BLAISE AD HAZOP

RMD-02-004

An interface HAZOP study was undertaken at BioConstruct's offices at Stockton-on-Tees, Teesside on 3rd June 2019, commencing on 4th June and being completed on 9th July, on the design of the proposed Anaerobic Digestion Facility for Crofthead.

This report details the findings of the HAZOP Study. The drawings used in the HAZOP study are found in the Drawings Section of this report and are based upon the following P&IDs:

Node 4

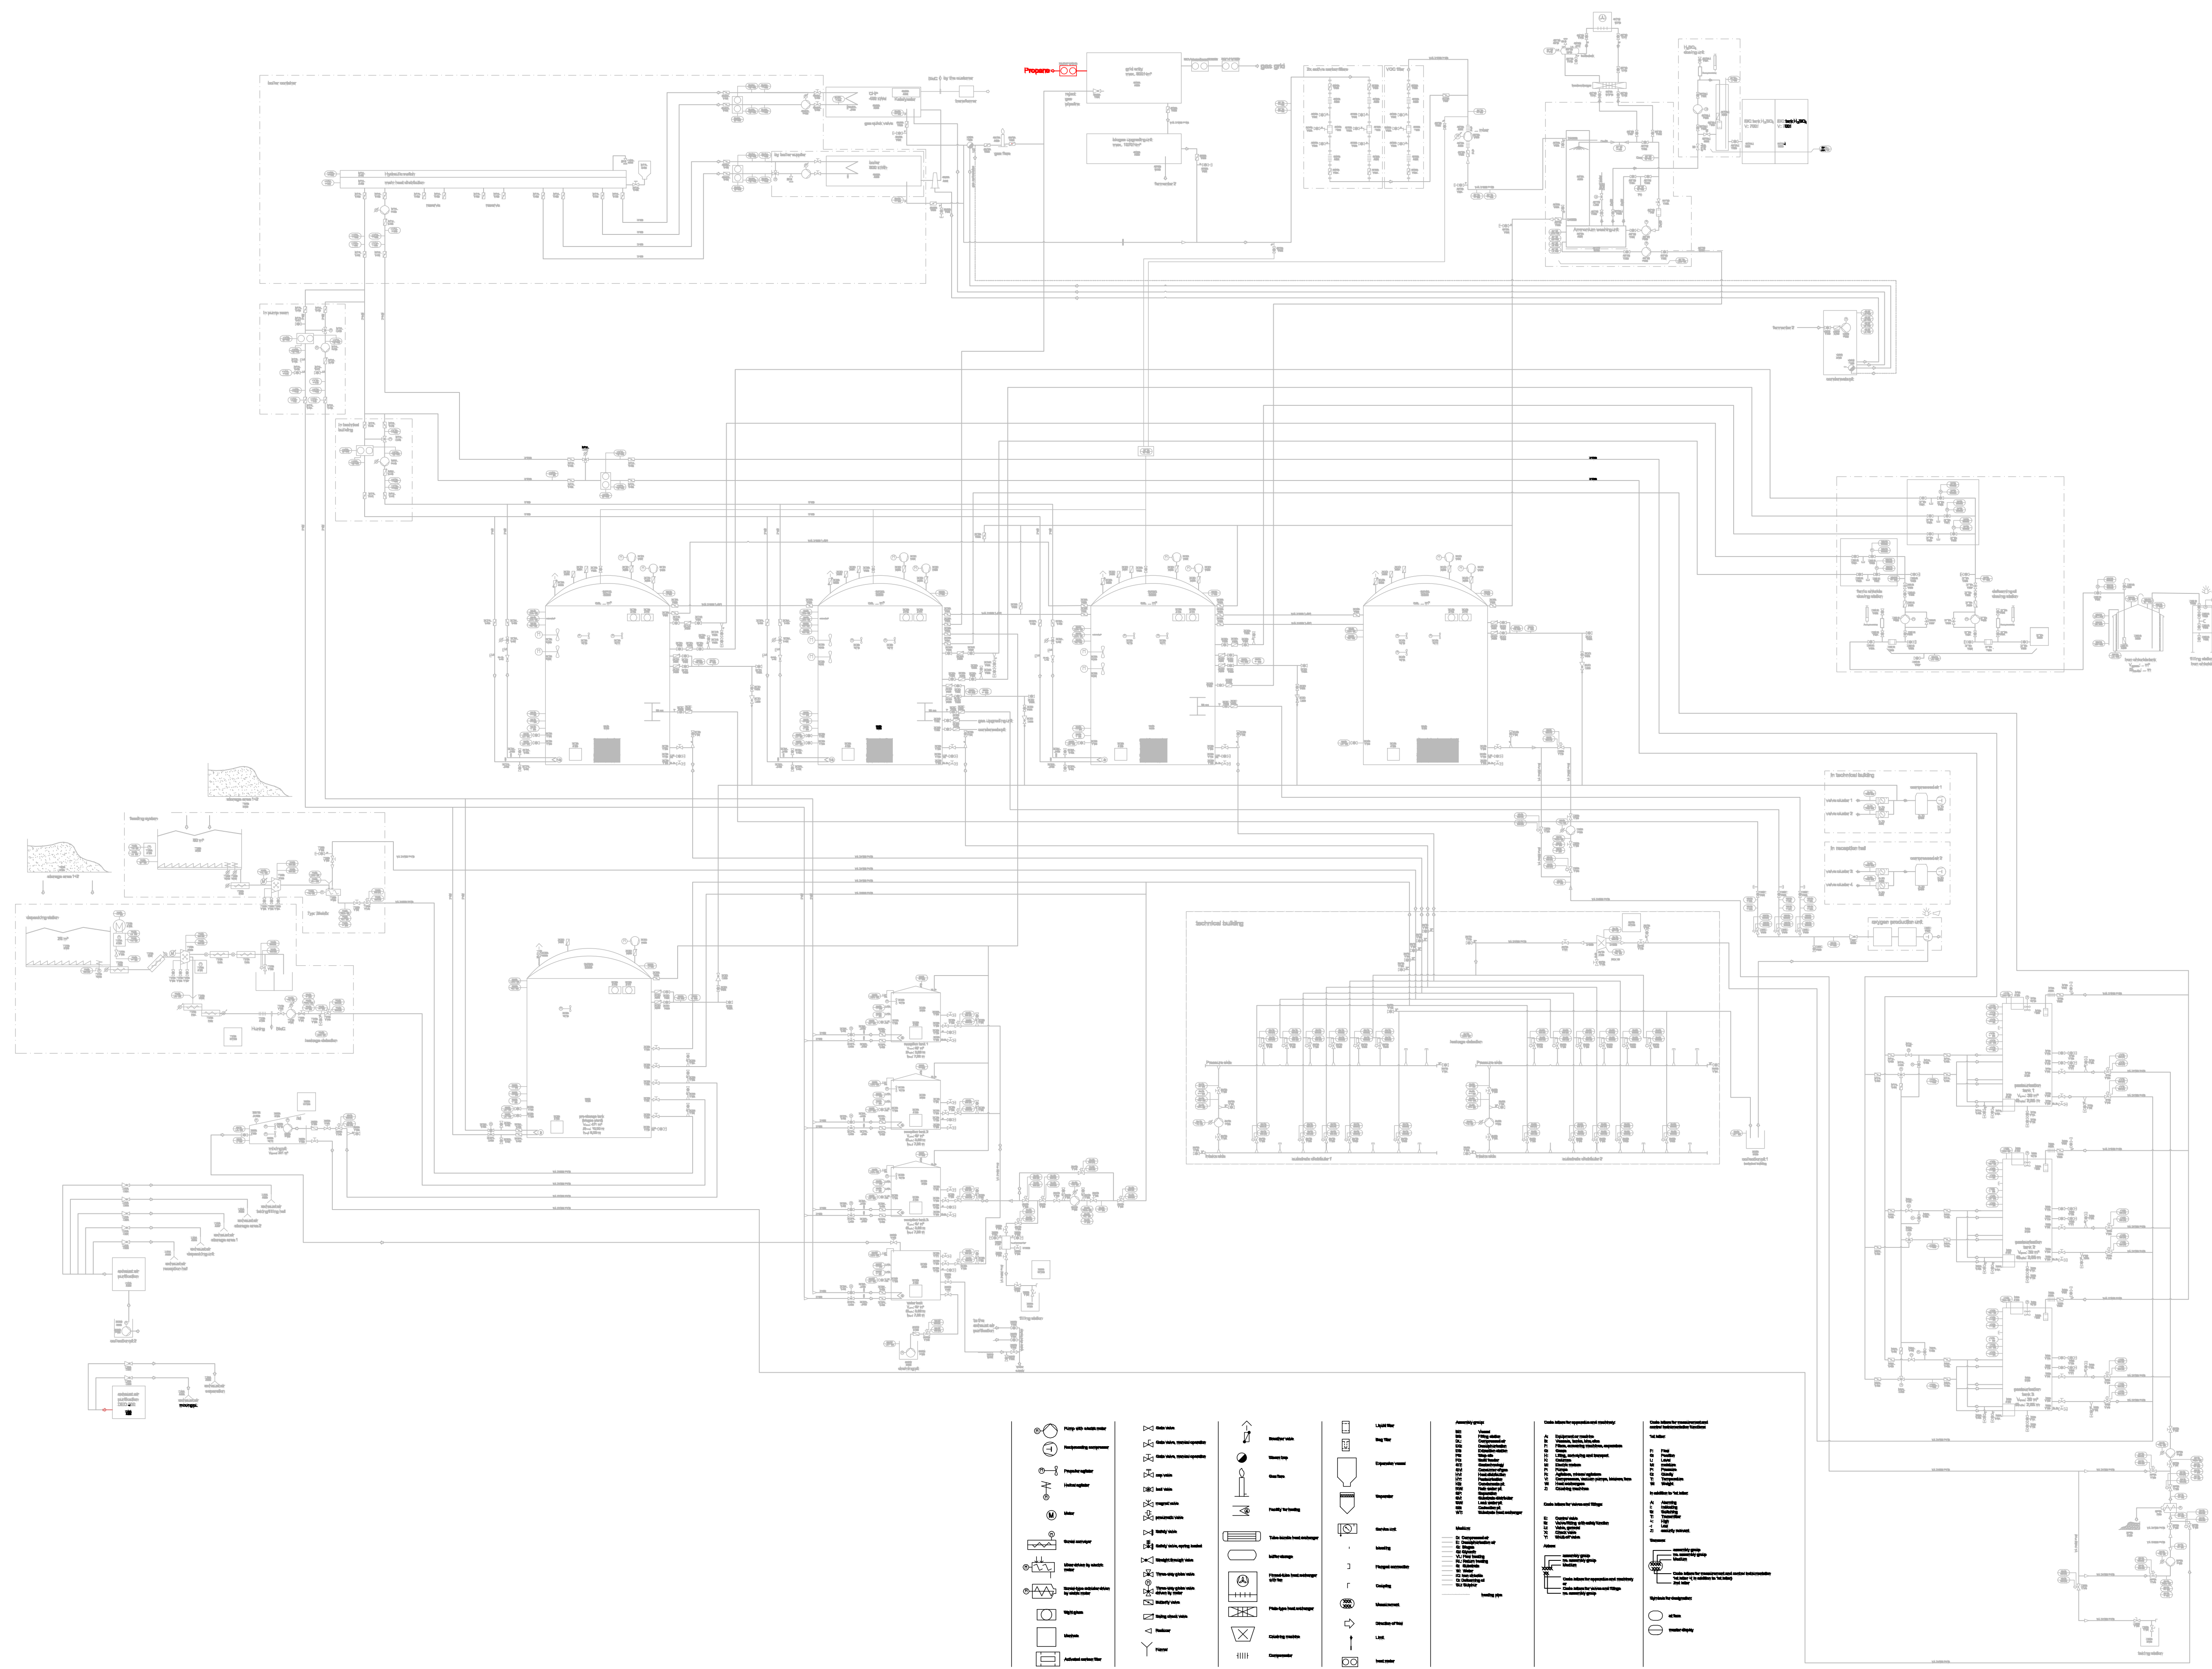
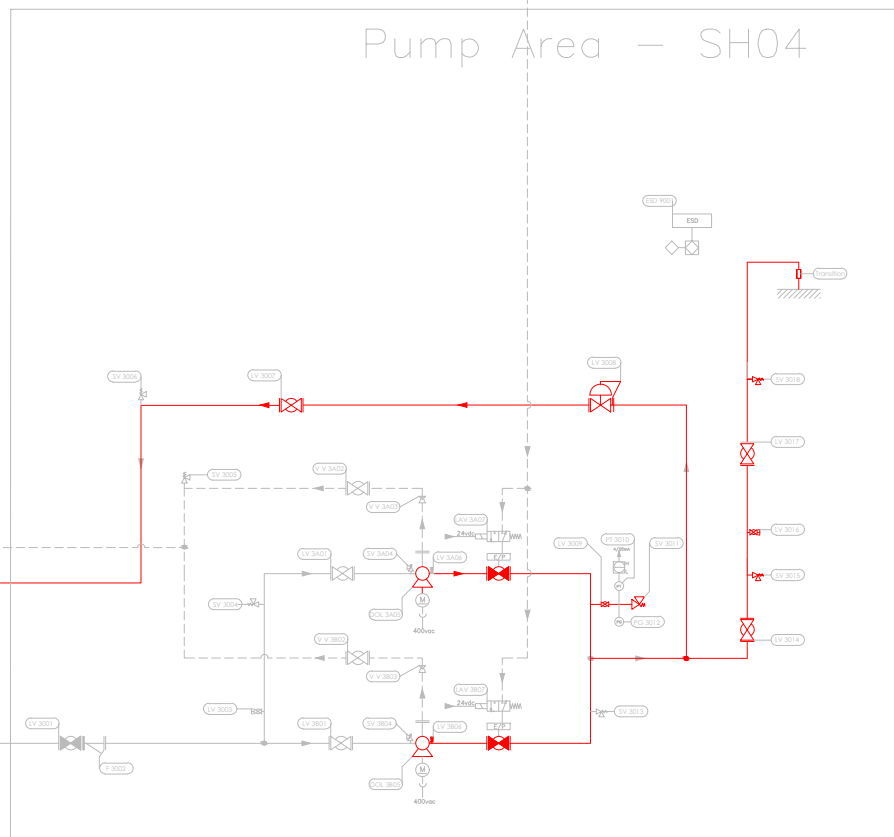
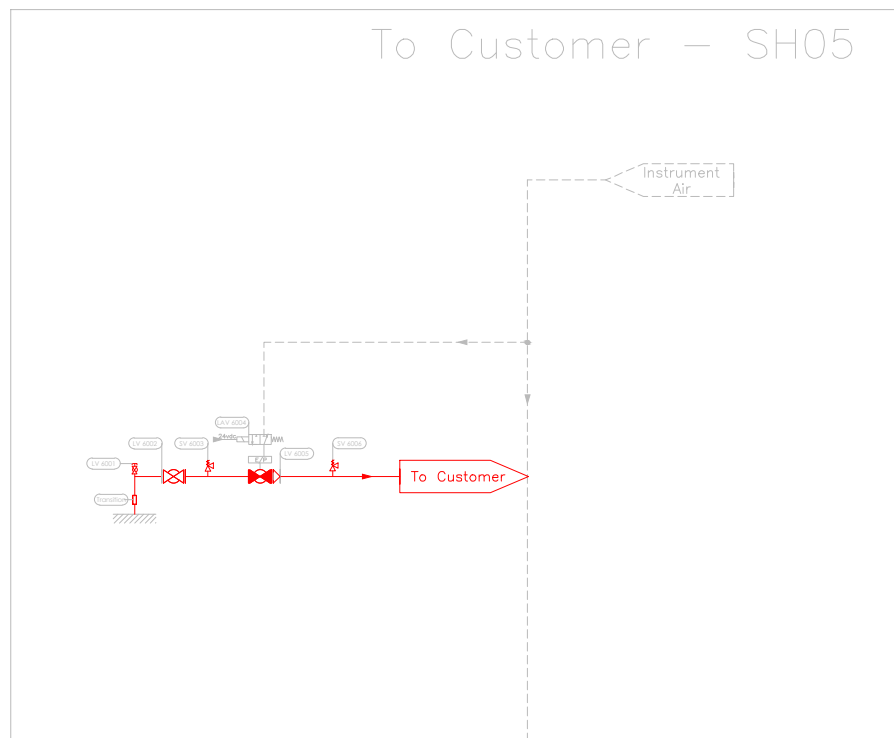
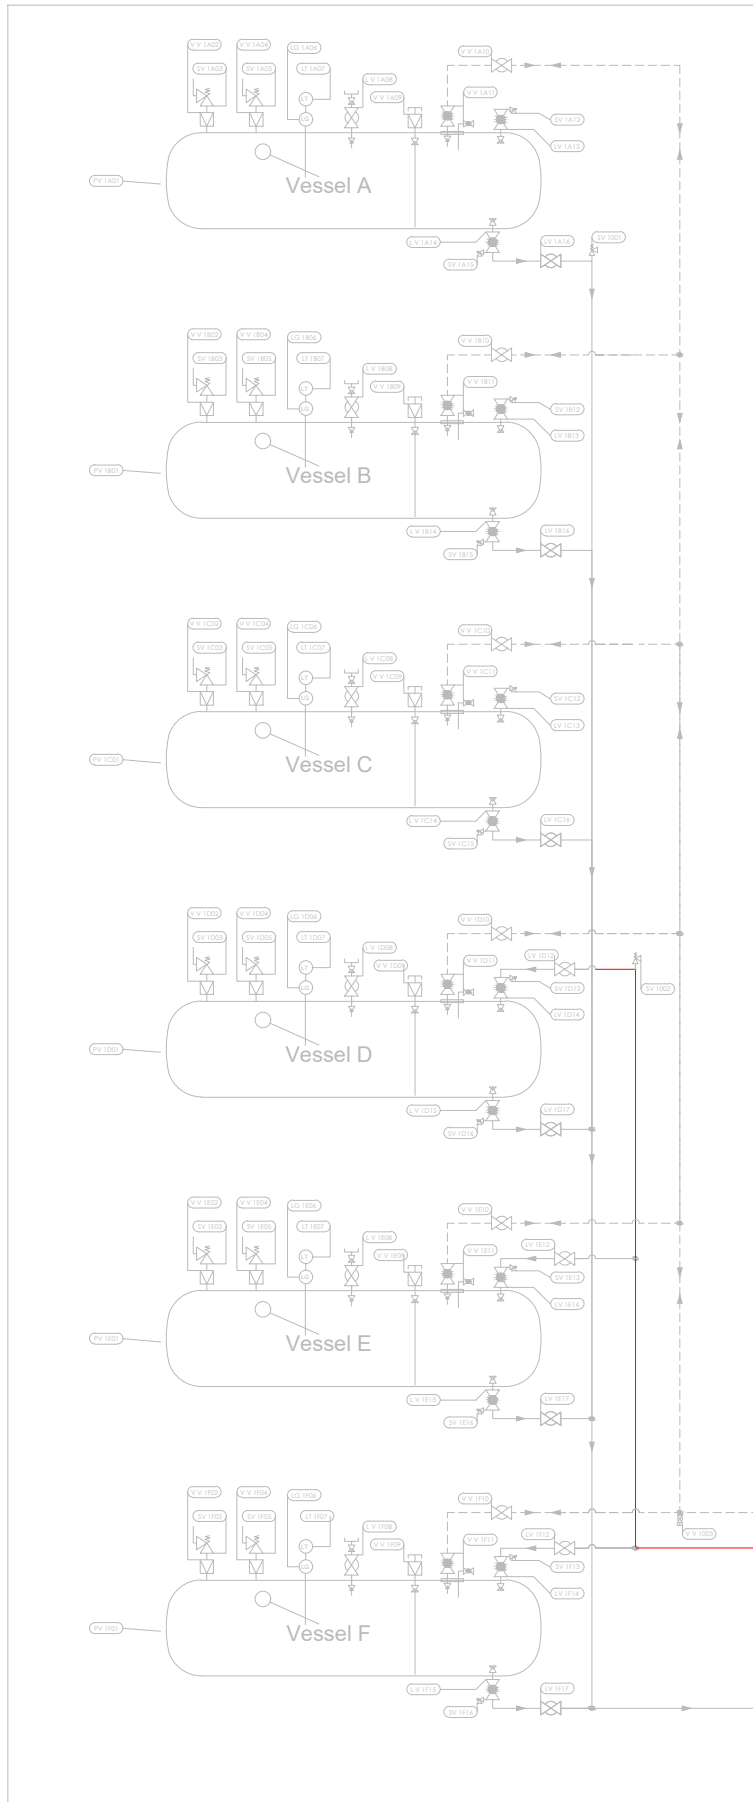
| ID/No. | Deviation | | No. | Possible Causes | Consequence | Safeguards | No. | Actions Required | Action Allocated to |
|--------|----------------|-------------|-------|--|---|--|---------|---|---------------------|
| 4.2 | More | Flow | 4.2.1 | Failure of spillback valve LV3008 | • Increase in pressure in propane line - increased fire and explosion risk | • Overpressure relief within Flogas system and GEU | | | |
| 4.3 | No | Flow | 4.3.1 | Failure of duty propane pump electrical mechanical failure | • Unable to propanate the biomethane resulting in reject | • Automatic start-up of standby pump on reduced pressure - on pump failure due to electrical failure there is a pump error signal. On low pressure if low pressure continues once standby pump operational both pumps will be shut-down an alarm signal is raised • Regular maintenance and inspection • Operator training | | | |
| | | | 4.3.2 | Manual valve LV 3014 /3017 closed when should be open normally open operator / commissioning / maintenance error | • Unable to propanate the biomethane resulting in reject | • Operator training • Pre-commissioning and post maintenance checks • Propane storage within separate secured compound | | | |
| 4.4 | Less | Temperature | 4.4.1 | Vaporiser malfunction electrical failure | • Inability to blend propane - failure to meet GSMR quality standards, biomethane to reject | • Regular maintenance and inspection • Alarms on the electrical breaker • Low temperature alarm on water and propane exit • Automatic valves 1 & 3 are closed until correct temperature achieved | | | |
| 4.5 | No | Flow | 4.5.1 | Tank runs dry | • Inability to blend propane - failure to meet GSMR quality standards, biomethane to reject | • Low flow alarm will shut-down GEU • Propane supply contract ensuring weekly top up of tanks • Level indication and telemetry on propane tanks will automatically trigger a delivery at 1/3 volume | | | |
| | | | 4.5.2 | Fractured propane line external to the GEU | • Loss of containment of propane and increased fire and explosion risk | • Low pressure alarm within GEU stops propane pumps | | | |
| | | | 4.5.3 | Propane line fracture within GEU | • Loss of containment of propane and increased fire and explosion risk | • Propane detection within GEU raises alarm • GEU rated ATEX zone 1 | | | |

| ID/No. | Deviation | | No. | Possible Causes | Consequence | Safeguards | No. | Actions Required | Action Allocated to |
|--------|----------------|-------------|-------|--|---|--|---------|---|---------------------|
| 4.1 | General Action | | | | | | 4.1.0.1 | Install manual isolation valve on propane inlet to GEU | Flogas |
| 4.6 | General Action | | | | | | 4.6.3.1 | Flogas to provide SRCPM with fire precaution requirements | Flogas |
